South Texas Project Electric Generating Station 4000 Avenue F – Suite A Bay City, Texas 77414

January 22, 2009
U7-C-STP-NRC-090006

South Texas Project
Units 3 and 4
Docket Nos. 52-012 and 52-013
Response to Request for Additional Information

Question Number: 02.03-06:

Figure 1: Comparison of Predicted and Observed Water Levels in the MCR for 2-Unit Operation from 1/2004 to 12/2005

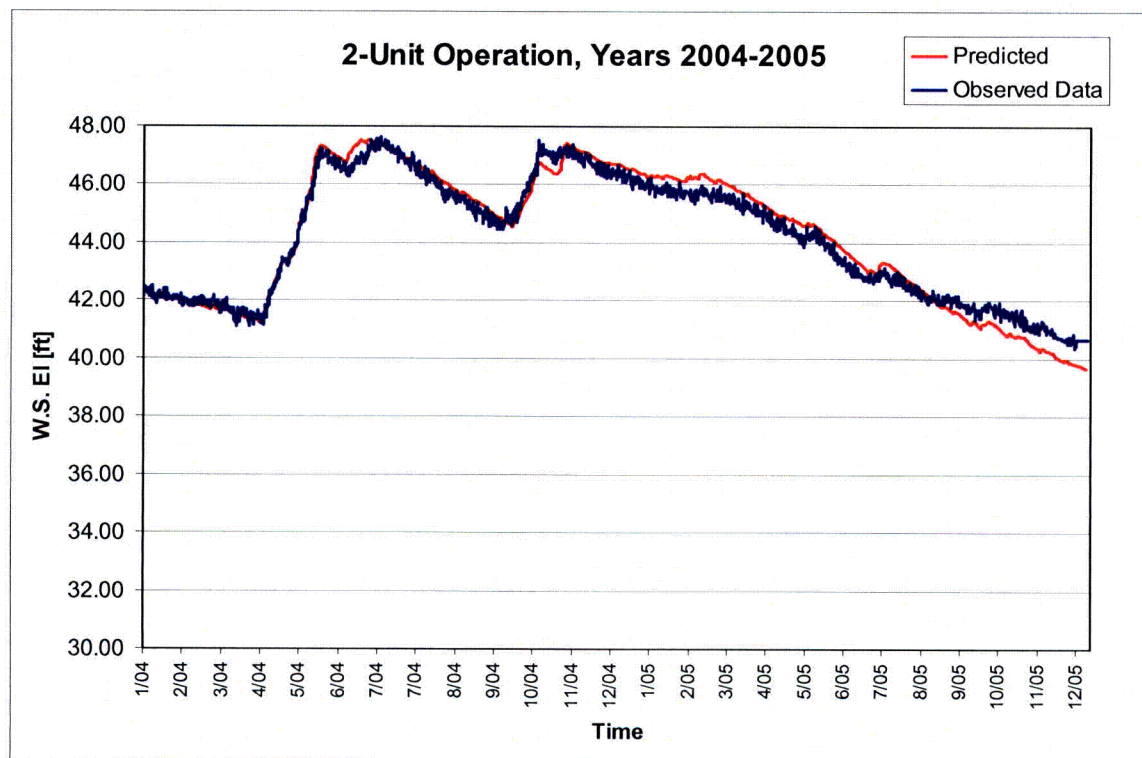
- Part 4: Provide water budget and water quality models of the MCR for two-unit and for four-unit operation taking into account the water withdrawal policy, LCRA permit limits, discharges to the MCR, seepage losses from the MCR, and blowdown from the MCR.

The predicted water surface elevations and the observed water levels in the MCR from 01/2004 to 12/2005 are shown on Figure 1.

Figure 8: Predicted Frequency of Operation of the RMPF for the 4-Unit Operation

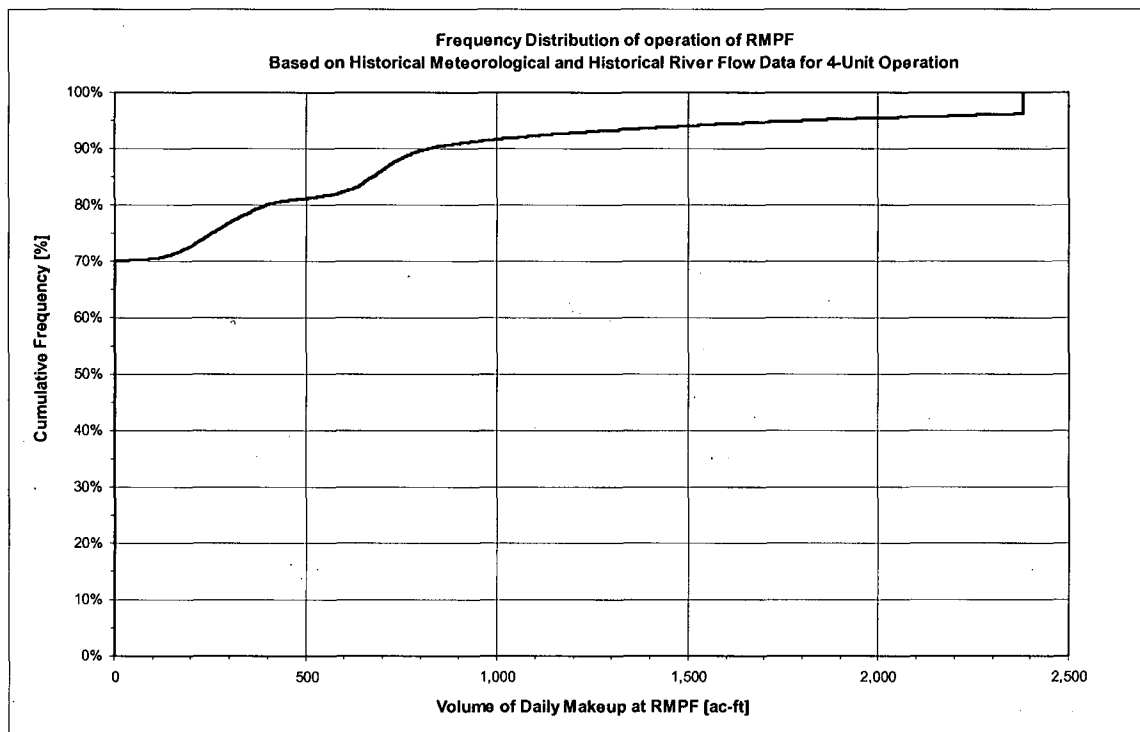
Provide details of frequencies of operation of the RMPF for existing two-unit operation and for future four-unit operation.

Based on the MCR water budget and water quality model presented in the supplemental response to Question Part 4, the frequency of operation of the RMPF for the four-unit operation has been estimated as shown in Figure 8. The results show that for almost 70% of the time, the RMPF will not be pumping. On the other hand, the RMPF will be pumping at its maximum capacity of 1200 cfs (2380 ac-ft per day) for approximately 4% of the time. The remaining portion of time (26%), the RMPF will be operating between 0 and 1200 cfs (0 and 2380 ac-ft of daily makeup volume).
